An Architectural Self - Criticism: The Accessibility Analysis of Berlika Park Swimming Pool

Berlika Park Swimming Pool, which was tendered by Meram Municipality, was chosen as the case study since I was one of the project owners and in the design team during my working period as a company partner, chief executive and architect in DKN Structural Engineering – Architecture Limited Company in 2010. The facility is located in sheet number M28, block number 37362, plot 2 in Meram district of Konya. It is a 100000 m² project with a two semi-olympic pools, wedding saloon about 6000 m², landscape and a theater. Swimming Pool's construction is 6000 m². The structure was constructed using reinforced concrete carcass. The facility was designed as two symmetrical pools. There are two semi-olympic pools, training pool, fitness center, pilates center, dressing rooms, bathrooms, showers, lifeguard rooms, Turkish baths, saunas, and steam rooms inside the building.

Photograph 1. Approach to the Building (Demirkan, 2015)

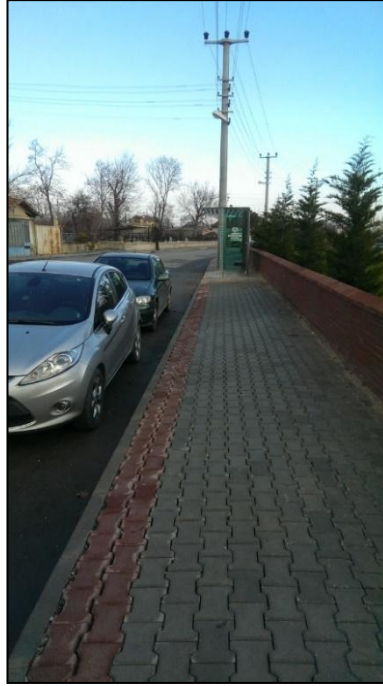
1. There is no handrail (TS 12576 Article 5.8).
2. There is no backrest above 45 cm of the seat (TS 12576 Article 5.5.1).
3. The width of the pavement is less than 300 cm in bus stops (TS 12576 Article 5.5.1).

4. It is not banned for other vehicles to stop or park within the bus stops by horizontal and vertical signs (TS 12576 Article 5.8). The information in the information board is missing.

5. No information about the route plan of each bus, the closest cabstand and important phone numbers on the information board (TS 12576 Article 5.8)
6. No tactile surface on the pavements (TS 12576 Article 5.1.5.1)

7. Power pole is in the middle of the pavement without any warning sign.
8. The curbstone isn't made with different material and color from the pavement overlay (TS 12576 Article 5.1.7.2).

9. The sidewalk of the bus stop isn't high enough, so there is a level difference between the pavement and the landing area (TS 12576 Article 5.8).

Photograph 2. Approach to the Building (Demirkan, 2015)

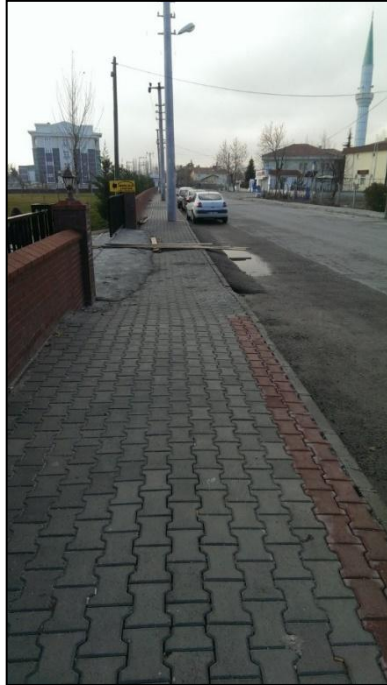
10. No space for a wheelchair adjacent to the seats in the bus stop (TS 12576 Article 5.5.1.)
11. There is no shiny, colored and reflective strip with 15 cm thickness and at a level of 100 and 140 cm (TS 12576 Article 5.8).

1. The guideboards aren't made of flat material and there isn't enough lighting (TS 1257 Article 5.6) (TS 9111 Article 4.8.6)
2. The screws used for the setup of power poles and traffic signs to the ground aren't arranged so that they aren't dangerous for the pedestrians (TS 12576 Article 5.1.7.1)

3. When the sidewalk behind the ramp isn't between 90 and 122 cm, a ramp of 1:12 (8%) should have been built in order to decrease the height of the pavement (TS 9111 Article 4.4.3.1) (TS 12576 Article 5.2)

4. No roadblocks are placed on the curbstone to prevent the car parking.
5. The ramps (above 5% slope) aren't covered with firm, non-skid and slightly rough material (TS 12576 Article 5.2.3).

6. There is no yellow-black warning sign is present during maintenance and repairs (TS 12576 Article 5.6).
7. No signing for the visually impaired individuals at the start and end of the ramps (TS 9111, Article 4.4.3.4)

8. The curbstone isn't made with different material and color from the pavement overlay (TS 12576 Article
9. No drainage gutter and grate on it to remove the surface water (TS 12576 Article 5.1.7.3)

10. In the event of maintenance and repair on the pavement, there is no audial and light warning, and the maintenance area

isn't surrounded with an obstacle at least 10 cm height (TS 12576 Article 5.1.6)

11. On two sides of the 150-cm pavement, there is no emergency lanes, 50 cm on the curbstone side and 25 on the property side (TS 12576 Article 5.1.1)

Figure 2. Entrance (Demirkan, 2012)

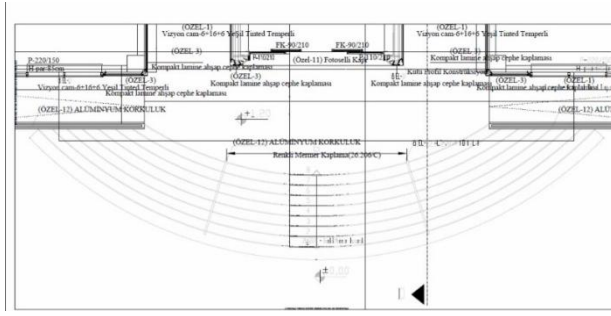
1. There are safety rails on both sides of the exterior stairway (TS 12576, Article 5.3)
2. There is no warning surface at the beginning and the end of the stairway (TS 12576 Article 5.3.2)
3. The front of the steps should be nosing and round (TS 12576 Article 5.3.3)
4. When the width of the stairs is more than 300 cm, there should have been a safety rail in the center of the stairs
5. The points of the rails aren't open, and they aren't in U shape (TS 12576 Article 5.3.3) (TS 9111, Article 4.7.1.3.3)

Figure 3. Ramp (Demirkan, 2012)

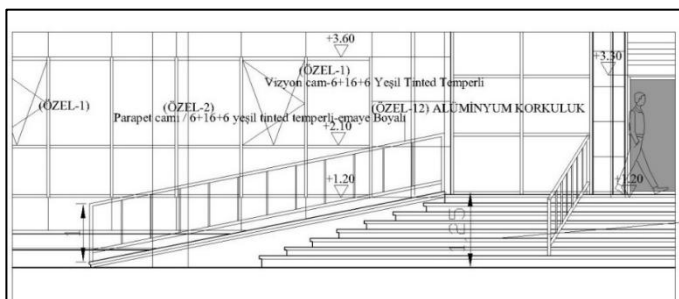
1. When the level difference is more than 100 cm, the slope of the ramp should have been 1:16
2. When the level difference is more than 100 cm after the ramp ends, the slope of the ramp should have been 1:16 and it should have been 30 cm longer (TS 9111)
3. The width of the ramp is 130 cm (TS 9111 Article 4.4.3.2)
4. The rail doesn't go 30 cm more than the ramp in the beginning of the ramp (TS9111, Article 4.4.3.4)
5. There is no first level rail of 70 cm height on the both sides of the ramp (TS 9111, Article 4.4.3.4)
6. There are second level rails of 90 cm height on both sides of the ramp (TS 9111, Article 4.4.3.4)
7. The ramp sign isn't consistent with the international signs (TS12576 Article 5.6)

Photograph 12. Elevator
(Demirkan, 2015)

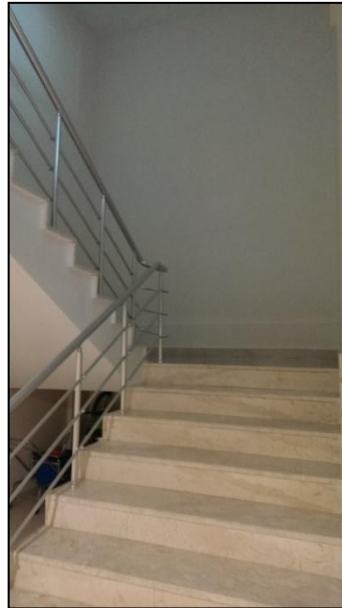
1. There isn't a space of 122 cm width and 76 cm deep for approach from the side (TS 9111, Appendix A).
2. There isn't two-way communication systems in the elevators (TS 9111, Appendix B)
3. The elevator call panel isn't placed between the height of 90 cm and 137 cm. TS 9111, Article 4.7.1.2
4. The size of the elevator cage doesn't fit the size of 150 cm width and 150 cm height (TS 9111, Article 4.7.1.2)
5. There is no accessible elevator (with all qualities) sign (TS 9111, Article 4.7.1.2)
4. There is no evacuation elevator in the building (TS 9111, Article 4.2)
5. There is no warning "don't use elevators during fire" in the elevator since there isn't an evacuation elevator. (TS 9111, Appendix B)

Photograph 13. Staircase
(Demirkan, 2015)

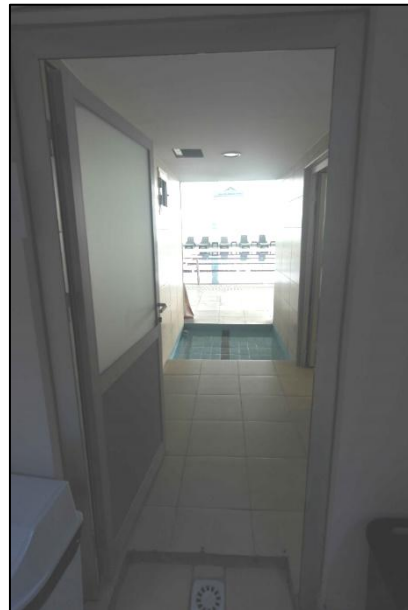
1. There is no information signs with braille on the railings.
* Since there isn't warning surface on the landing, warning tapes aren't placed on landing in rectangle and shape and crosswise

* The stairs doesn't fit the formula of $2a(\text{riser}) + b(\text{the depth of stair}) = 60-64 \text{ cm}$ * No landing for each 8- 10 stairs (TS 9111, Article 4.7.1.3)

2. There is no 30 cm and 60 cm length perceivable surface at the end and beginning of the stairs and on the landing, respectively (TS 9111, Article 4.7.1.3)

3. There is no non-skid tape on any of the stairs (TS 9111, Article 4.7.1.3) The stair material is composed of slippery and shiny materials (TS9111, Article 4.7.1.3)

4. There is no visual warning tape (preferably yellow) on the first and last stairs of stairway and on the landing (TS 9111, Article 4.7.1.3)
5. The front of the stairs is nosing (TS 9111, Article 4.7.1.3).

6. There is no rail at the height of 70 cm on the railings (TS 9111, Article 4.7.1.3)

Photograph 14. To the pool (Demirkan, 2015)

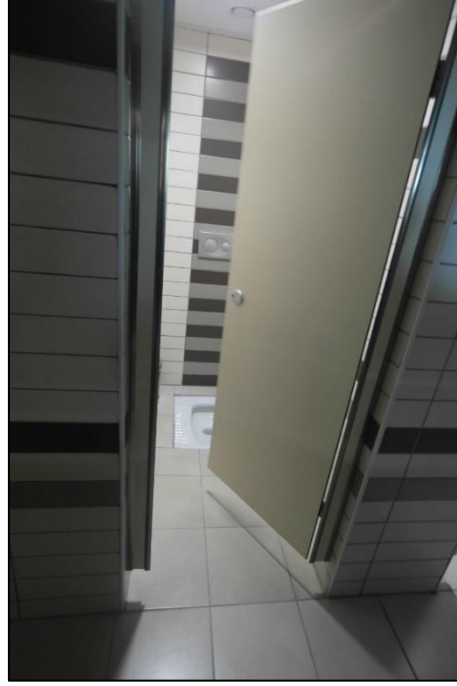
1. There isn't a space of 90 cm width and 220 cm height without obstacles inside the corridors.
2. Floor coverings are made of slippery materials (TS 9111, Article 4.6.1)

Photograph 16. Baths
(Demirkan, 2015)

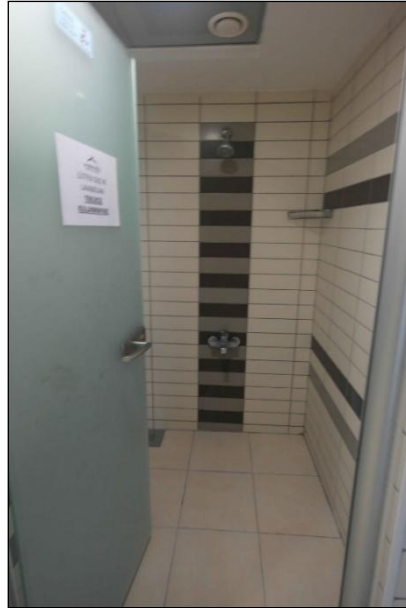
1. The height of the soap dispenser isn't between 80 and 110 cm (TS 9111, Article 4.7.3).
2. The doors are made of glass and there is no singing for visually impaired individuals (TS 9111, Article 4.6.2).

Photograph 19. Pool
(Demirkan, 2015)

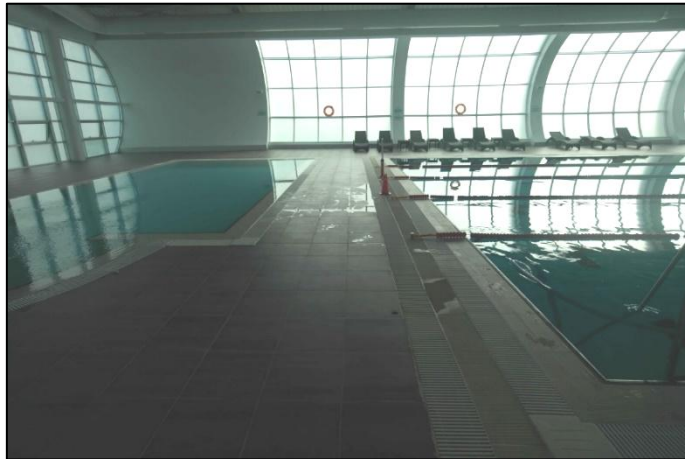
1. There is no hearable audio alarm. Article 9.1
2. There is no visible alarm system.
3. There is no necessary warning sign.
4. There is no perceivable floor. (TS 12576 Article 5.1.5.1)
5. There is no pool elevator or lift for disabled individuals.
